**Building or Use Permit Pre-Application  
Attached Single Family Dwellings/Two-Family Dwelling  
Multi-Family or Commercial Structures and Additions Thereto**

Location/Address of Construction (include Portion of Building): <i>2325 CODMAN ST</i>			
Total Square Footage of Proposed Structure <i>240 sq ft</i>		Square Footage of Lot <i>7122.5 sq ft</i>	
Tax Assessor's Chart, Block & Lot Number Chart# <i>129</i> Block# <i>G</i> Lot# <i>15</i>		Owner: <i>MARK G. ORLANDO</i>	Telephone#: <i>775-1817</i>
Owner's Address: <i>25 CODMAN ST</i>		Lessee/Buyer's Name (If Applicable)	Cost Of Work: <i>\$600-</i> Fee <i>\$30.00</i>
Proposed Project Description: (Please be as specific as possible) <i>ADD SECOND LEVEL TO FRONT PORCH. ADDITION WILL PROVIDE FOR A COVERED FIRST FLOOR PORCH AND AN OPEN DECK FOR SECOND STORY</i>			
Contractor's Name, Address & Telephone <i>N/A</i>			Rec'd By <i>(Signature)</i>
Current Use: <i>Porch 2 unit</i>		Proposed Use: <i>Porch Sun</i>

BUILDING PERMIT REPORT

DATE: 8 June 2000 ADDRESS: 23-25 Godman ST CBL: 129-G-015

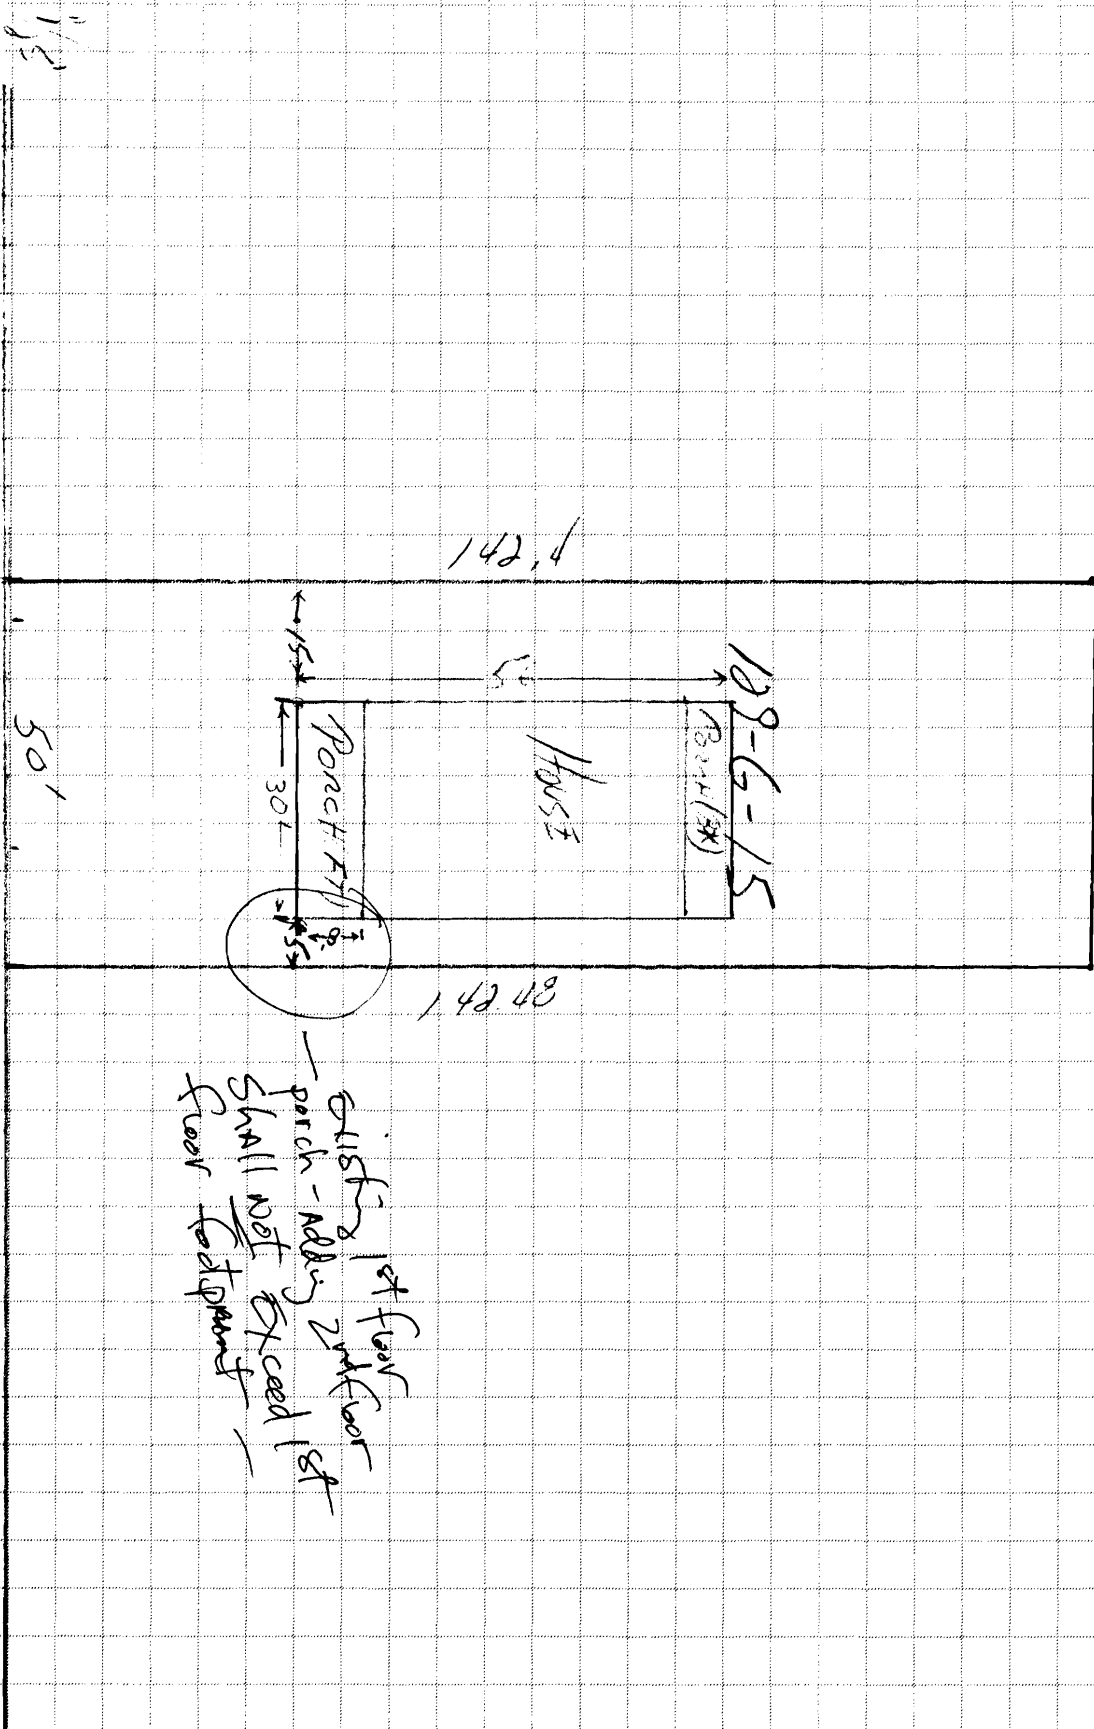
existing 1st floor porch - adding 2nd floor  
 shall not exceed 1st floor footprint

*This porch/deck shall not exceed the size of the original footprint*

X 36. The proposed 10" x 10" columns shall be placed on a foundation 4" below grade on footing with fasteners between.
